SAFETY RECALL

Brake Fluid Flush Voluntary Safety Recall Campaign

Reference: R1814
Date: March 29, 2019

REVISED March 29, 2019
Please discard earlier versions of this bulletin.

BRAKE FLUID

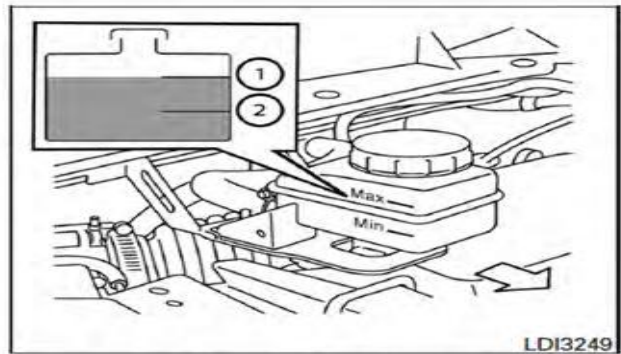
Check the fluid level in the reservoir. If the fluid is below the MIN line ② or the brake warning light comes on, add Genuine NISSAN brake fluid CLARIANT 6M DOT4 or equivalent DOT4 up to the MAX line ①. If the fluid must be added frequently, the system should be checked by a NISSAN dealer.
